Vermont Agency of Transportation  
TOP 66 11-07

Town of Rochester, Vermont. Bridge 15

BRF 0162(16)

**Traffic Control Plan**

PROJECT NAME:	ROCHESTER
PROJECT NUMBER:	0162(19), 0162(16), 0162(17), 0162(18)
FILE NAME:	zllc334Regionaldetour.dgn
PLOT DATE:	9/16/2013
PROJECT LEADER:	S.E. BURBANK
DRAWN BY:	C.L. CILLEY
DESIGNED BY:	M.D. SUENEN
CHECKED BY:	G.S. GOODRICH
REGIONAL TCP (1 OF 5)	SHEET 8 OF 238

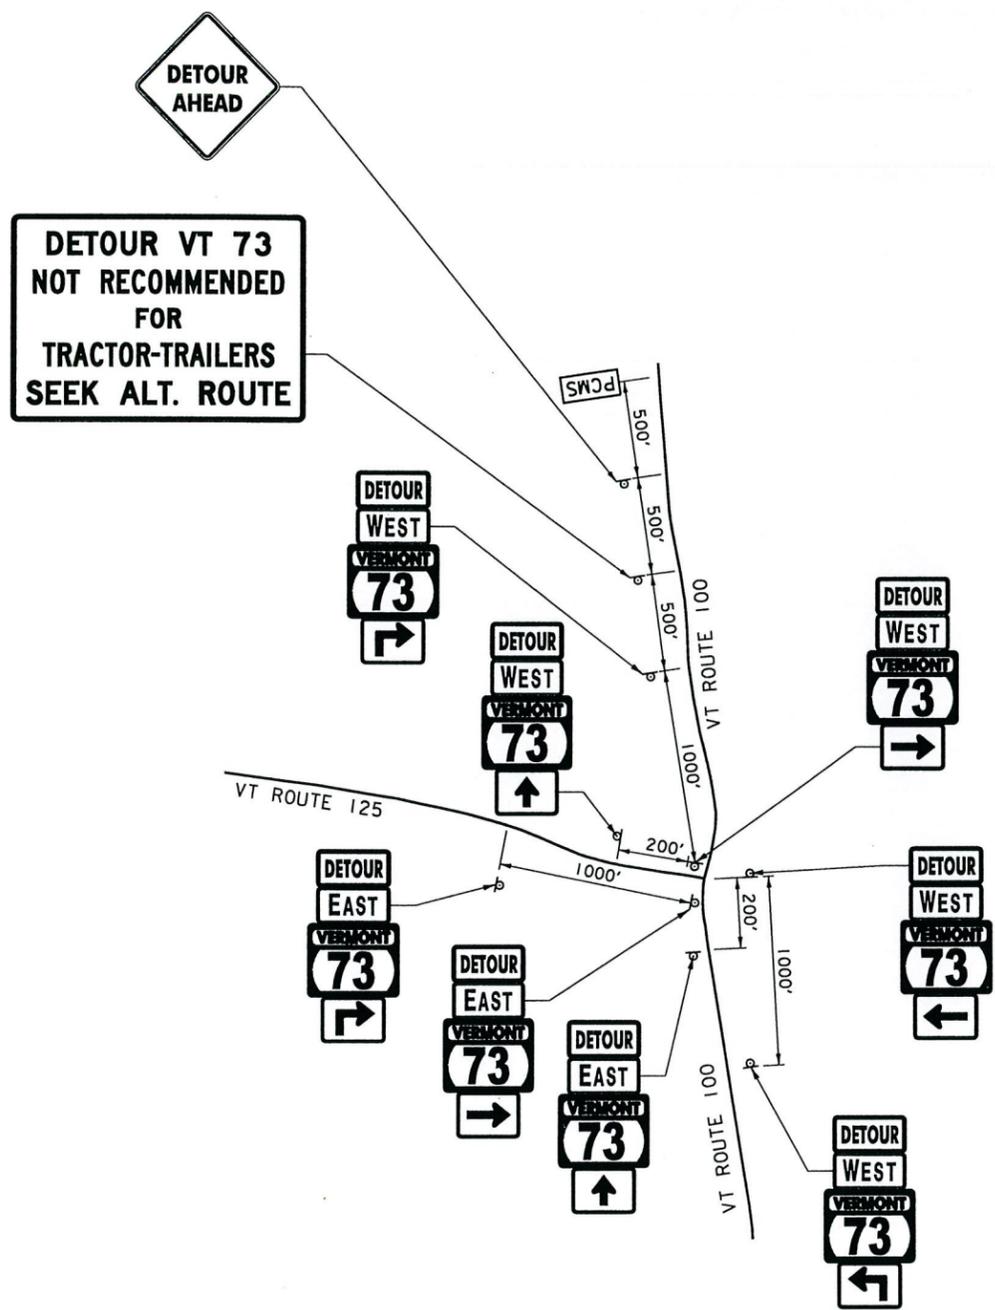
3. The Agency will provide the Contractor with a received Regional Traffic Control Plan that includes additional signage to be added to the current detour signs and confirmatory route markers and messages to be displaced on the portable changeable message signs as required for detouring trucks.

4. The Contractor shall install the additional signs as shown on the revised Regional Traffic Control Plan prior to detouring truck traffic. Per the contract documents the detour signs shall be covered aft the additional signs have been added and uncovered immediately prior to implementing the truck detour route (exact time to uncover the truck detour signage for the truck detour is to be coordinated with the Resident Engineer).
